Planning Committee Meeting to be held on Monday 8 November 2021 at 6.30pm.

5.1 APPLICATION FOR PLANNING PERMIT D/66/2021 11 Berwick Street, Reservoir

| 11 BERWICK STREET, RESERVOIR | | REVISION | SHEET No. |
| THREE TOWNHOUSES | | C | TP1 |

SITE/GROUND FLOOR PLAN
1 : 100

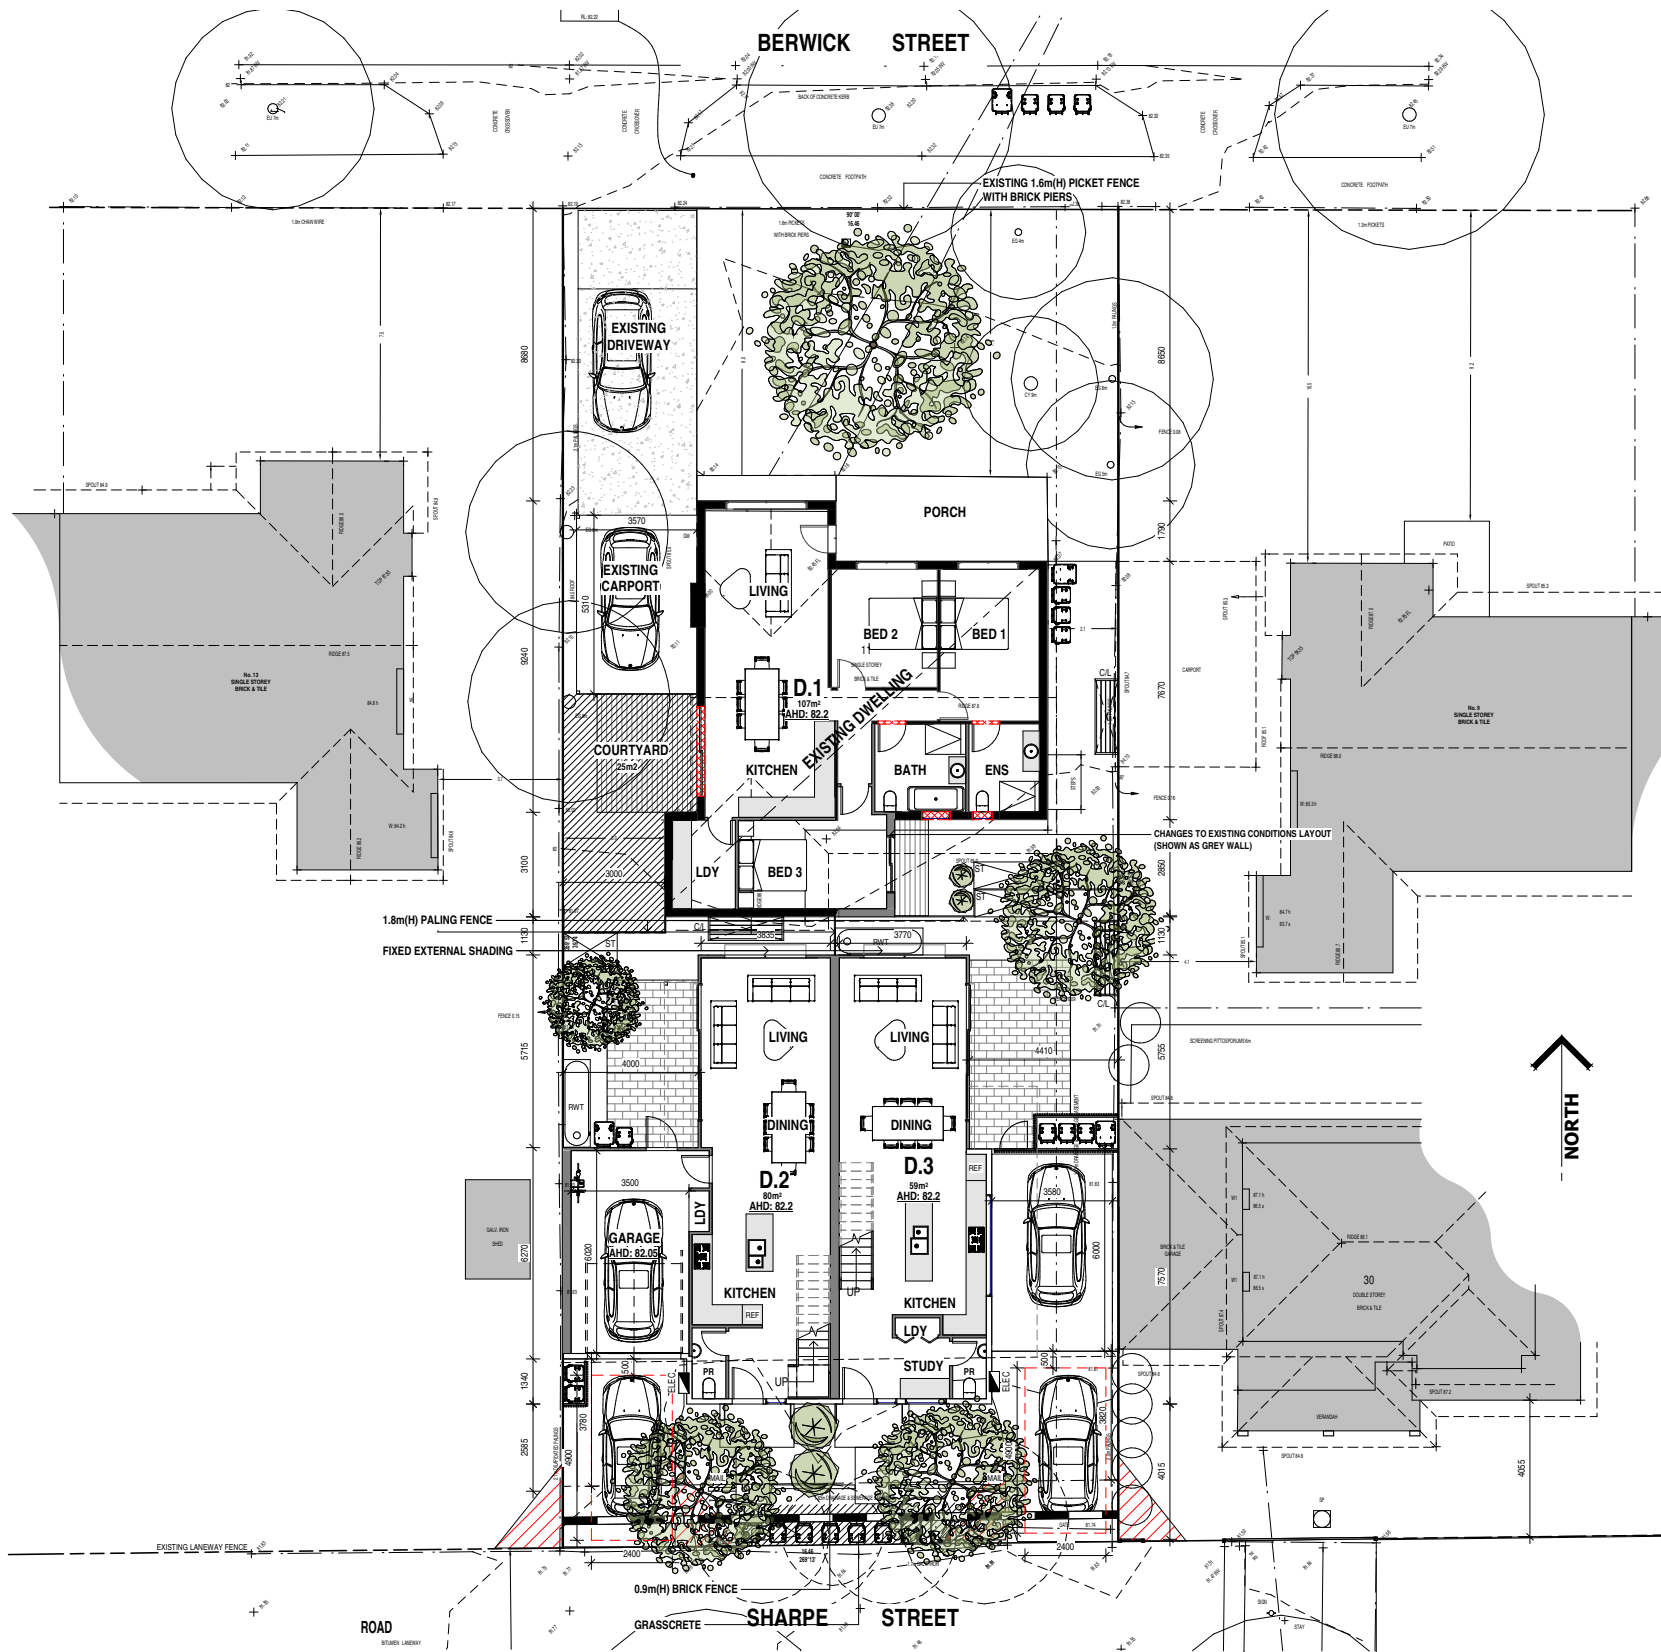
- (a) Details of the external storage facilities provided for the dwellings, with a minimum volume of 6 cubic metres.
 - (b) Details of the fence on the eastern boundary (except within 8.6 metres of the Berwick Street frontage and 4.15 metres of the Sharpe Street frontage) in accordance with Condition No. 9 of this Permit.

- (e) The provision of pedestrian visibility splays measuring 2.0 metres (width across the frontage) by 2.5 metres (depth into the site), to the eastern and western sides of the existing and proposed crossovers to Berwick Street, Sharpe Street and the right of way. Where within the site, the splays must be at least 50% clear of any visual obstructions (structures, vegetation and the like). The splays may include an adjacent entry or exit lane where more than one lane is provided, or adjacent landscaped areas, provided the landscaping in those areas is less than 900mm in height.

The height of part of the fence on the eastern boundary does not provide sufficient privacy between the dwellings. A condition of approval will require the fence height to be increased to 1.8 metres to appropriately address overlooking.

FIRST FLOOR PLAN
1 : 100

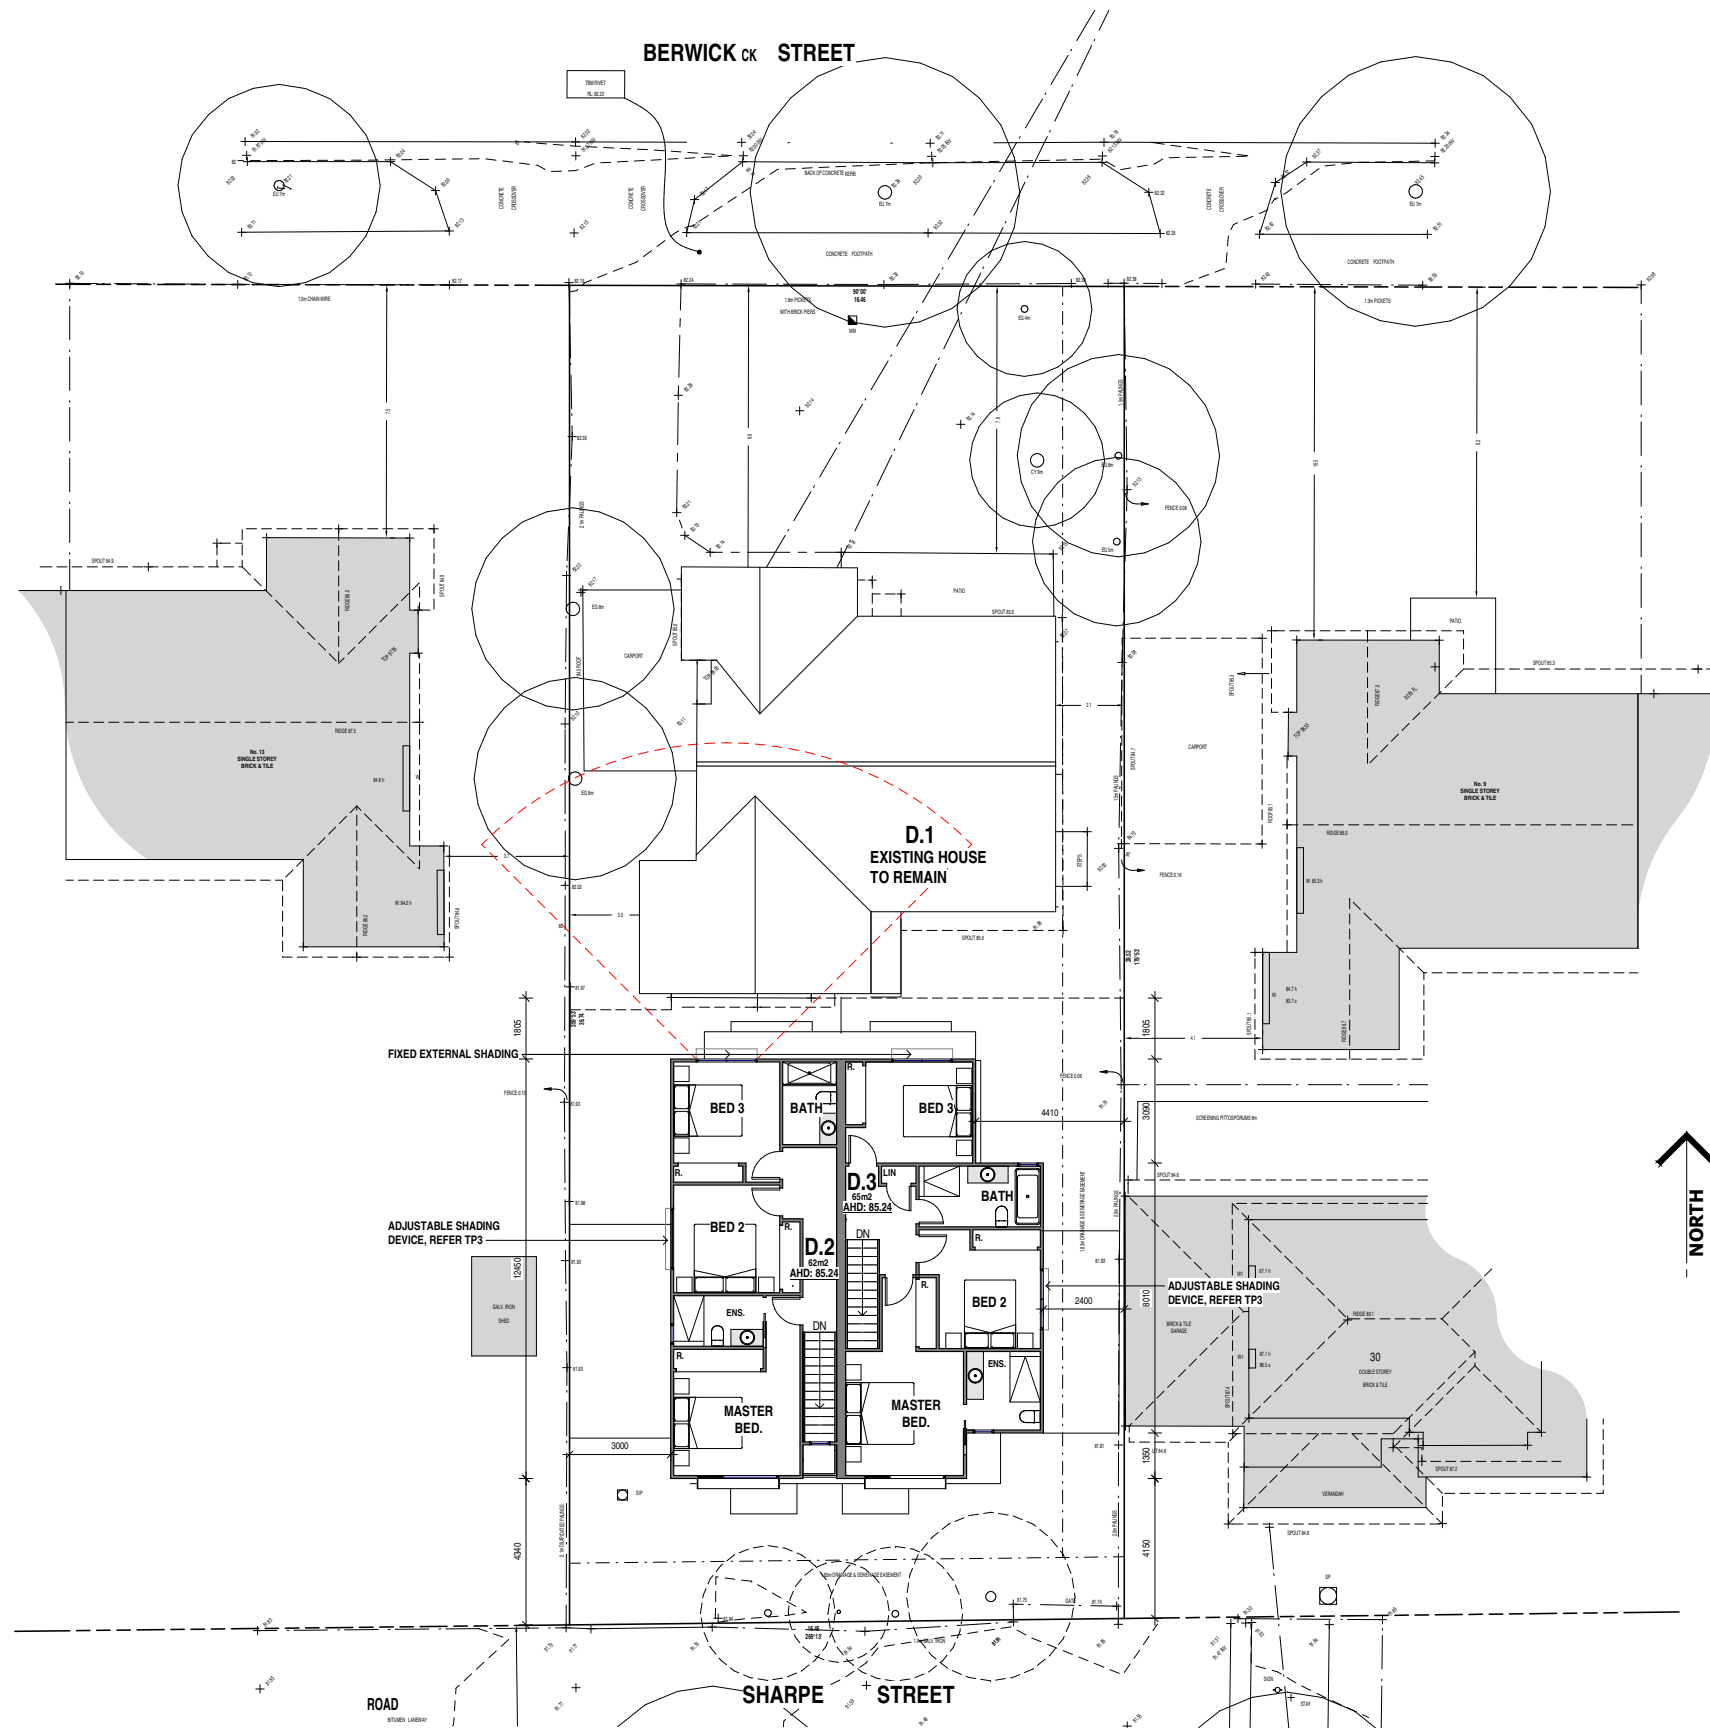
Whilst the plans indicate the upper level windows are treated to address overlooking a condition of approval will require further details to be provided in accordance with the requirements of the standard.

WSUD PLAN
1 : 100

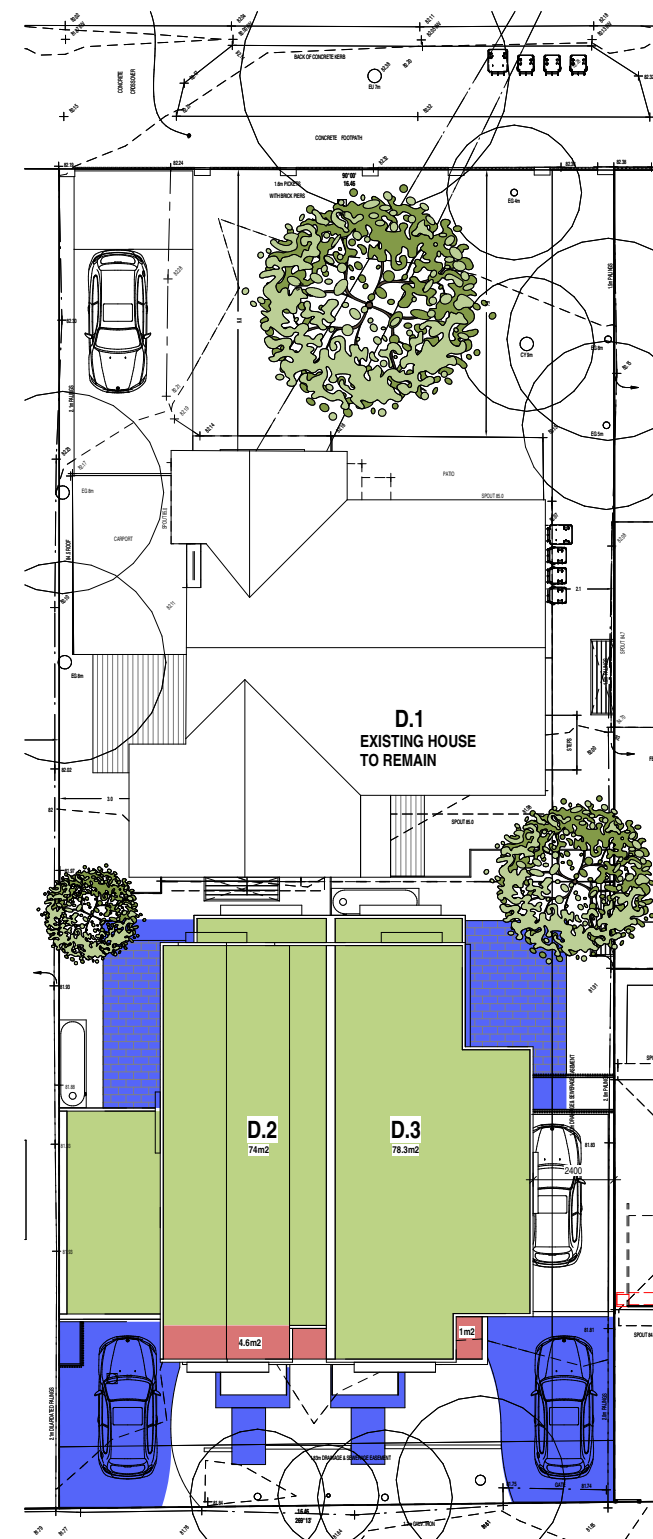
A STORM report has been provided with the application, that demonstrates a 101% STORM rating and a suitable WSUD plan.

TURNING CIRCLES/TPZ PLAN
1 : 100

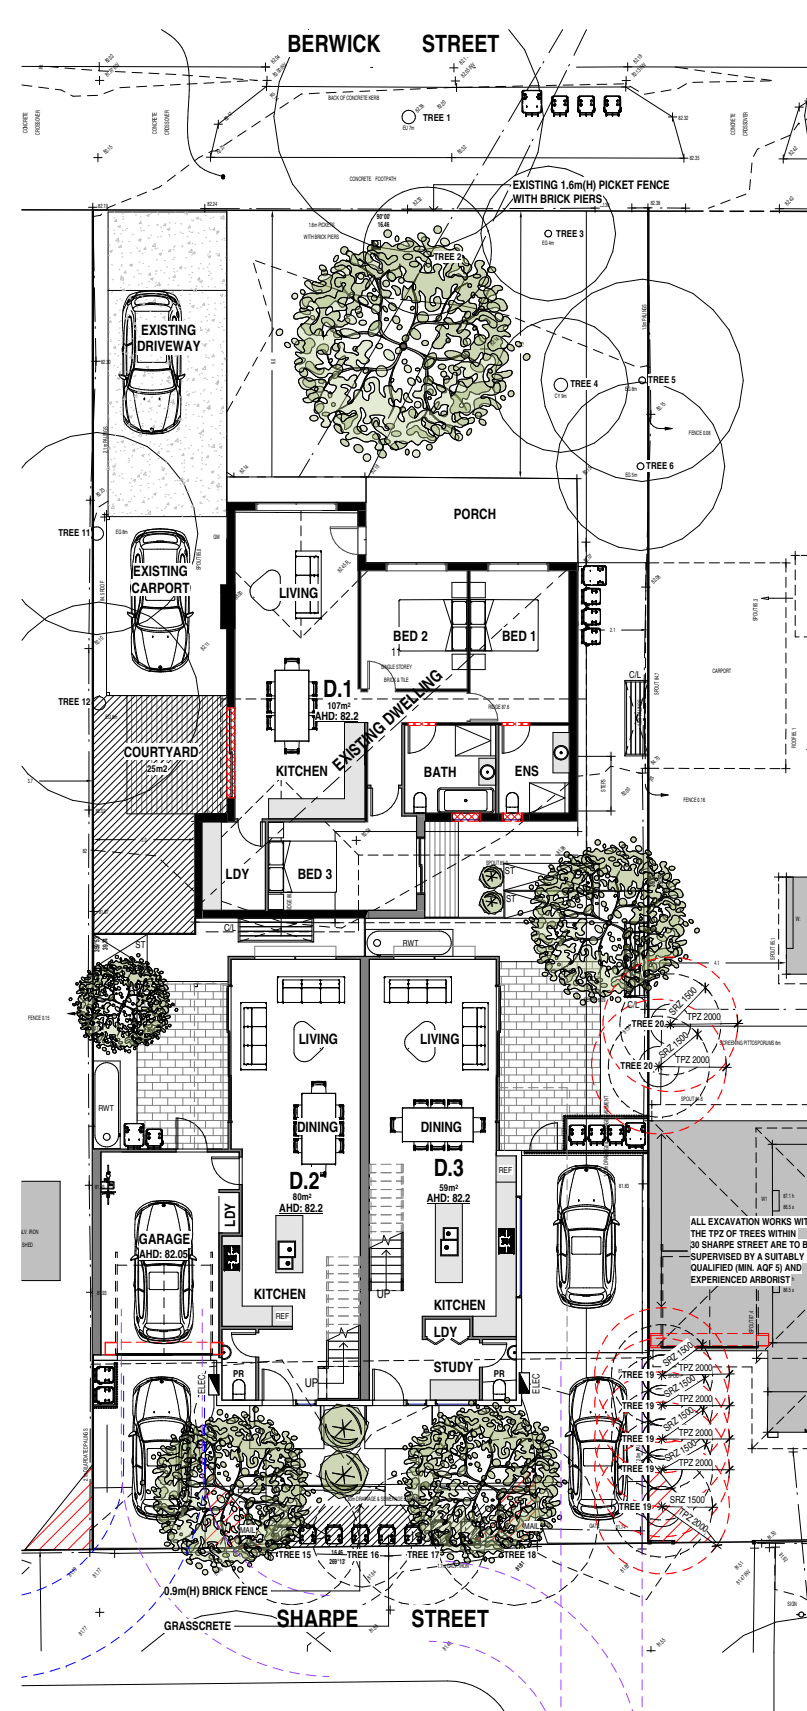
| Department/Authority | Response |
|---|---|
| Climate and Transport Unit Emergency and Sustainable | <p>Comments received 14 April 2021</p> <p><i>Swept path diagrams prepared by a suitably qualified person to demonstrate that vehicles can enter and exit unit – 2 and unit – 3 garages depicted on the plans.</i></p> <p>Officer Comments: Swept paths were provided by the applicant and deemed acceptable.</p> |
